Access Compliance Report

Public Rights-of-Way

| Intersection ID: 12299 | Main Street: W_MOREHEAD_ST | Cross Street: S_CHASE_ST | Location: E |
| ADA ID: 87C11A936302 | Ramp Type: PerpDiag | Initial Pass/Fail: Fail | Overall Compliance: No |

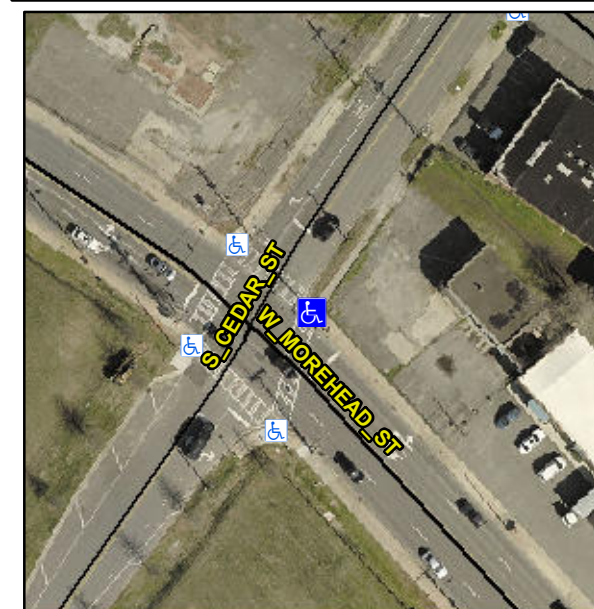
Not Found, R304.2.2, R304.5.3

| Compliance | Description | Data | Compliance | Description | Data |
|------------|-----------------------|-------|------------|-----------------------------|-------|
| N/A | Ramp Length (in) | 64.0 | No | Ramp Slope (%) | 9.0 |
| Yes | Ramp Width (in) | 48.0 | No | Ramp XSlope (%) | 7.0 |

Remove & Replace Curb Ramp With Two New Directional Ramps or Equivalent.
